Our ref: 14891 RG

18th April, 2007

RE: PAVILION BUILDING - ST MARYS RECREATION GROUND

EXISTING CROSS SECTION

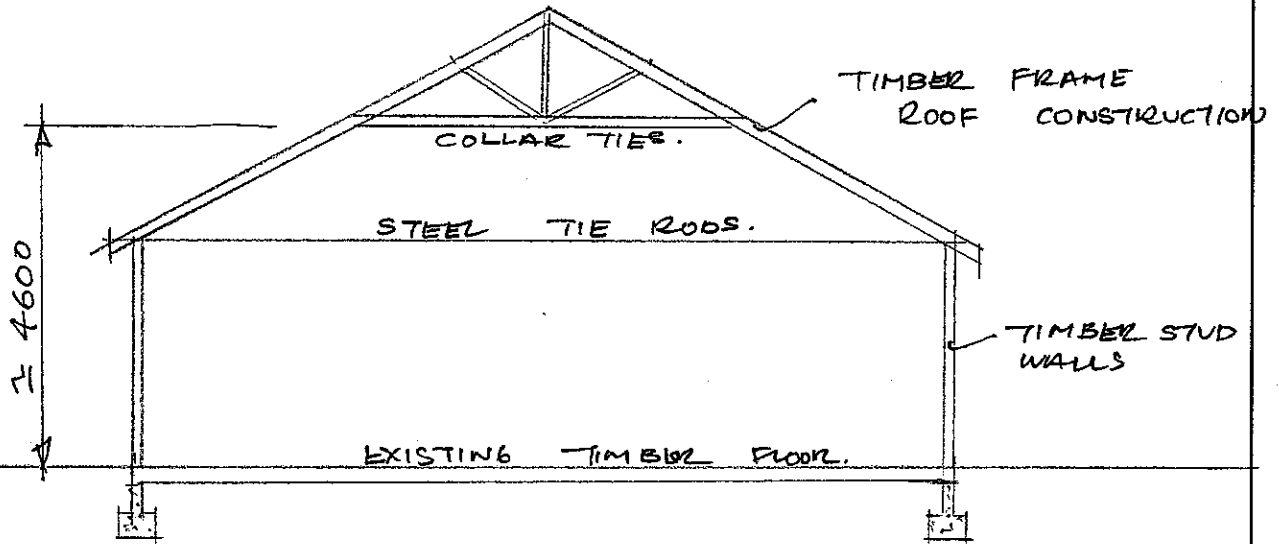
- Roof framing consists of 125 x 50mm hard wood rafters @ 600 crs with collar ties. However the rafters have bent at the collar tie location and steel tie rods have been placed at wall top plate level in 6 locations along the building. This is not very satisfactory
- There is no ceiling and infact the existing structure will not support a ceiling
- Roof bracing is not sufficient. It does not comply with today's Wind Code. Roof bracing is being provided by the corrugated iron cladding
- Walls are of timber stud construction and clad on the outside with vertical hardwood boards in fair condition. Internal linings are hard board. There is no way of checking the extent of any wall bracing without removing all the internal linings

PROPOSED CROSS SECTION.

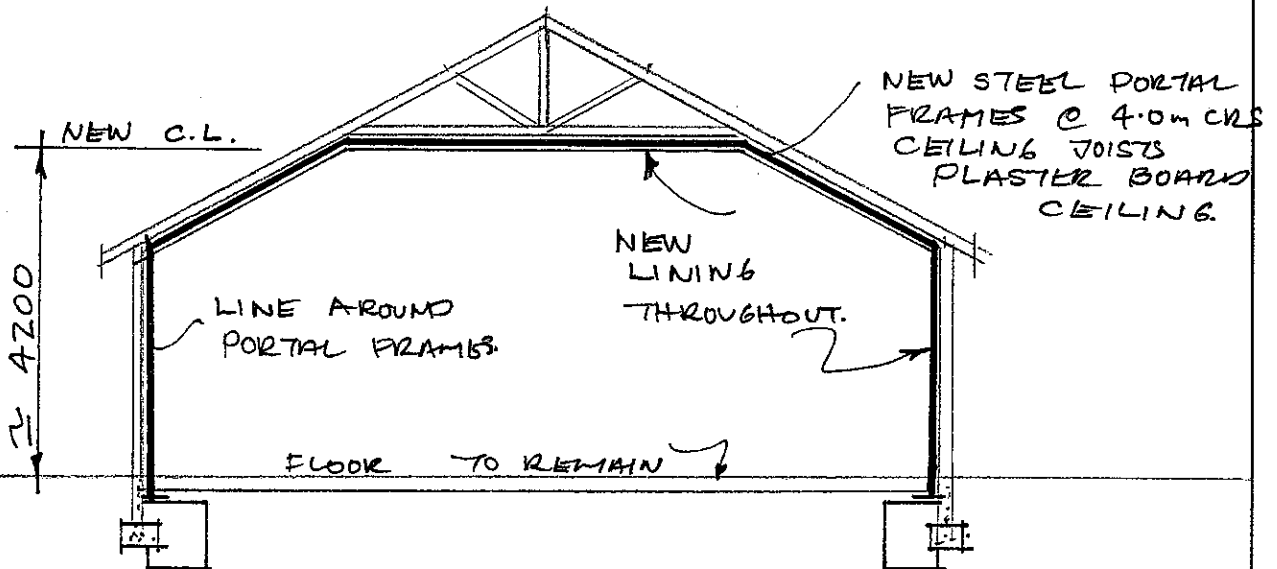
- Clear out drains along the east and west sides of the building where silt and debris have built up
- Replace roof cladding with new custom orb Colorbond complete with flashings and eaves gutter and down pipes
- The existing external cladding of vertical timber boards is generally sound for its age. There is no need to replace the cladding. Replace individual rotten and split boards. Repaint exterior
- The need to put in a ceiling, and address the problem of a lack of bracing may be overcome with the addition of some steel portal frames. These would be placed inside the building at approximately 4.0 metre centres.

They will perform the dual purpose of supporting a new ceiling and the lack of lateral bracing in the building. Installing portal frames will mean that the outside building appearance will remain the same
